Site AS-13

AS-13: Roeshot, Christchurch

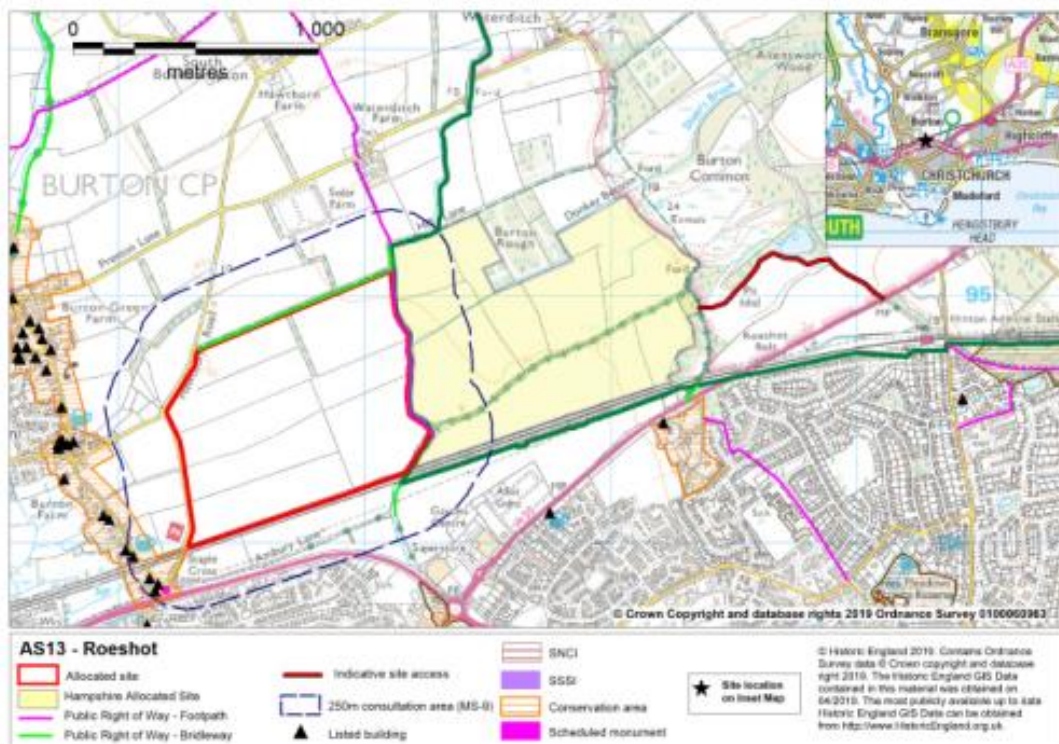
It is expected that site access will already have been established through the development of the eastern part of the site within Hampshire - as shown on the plan below (MM 45).

Insert revised plan, showing 250m consultation area and indicative quarry access
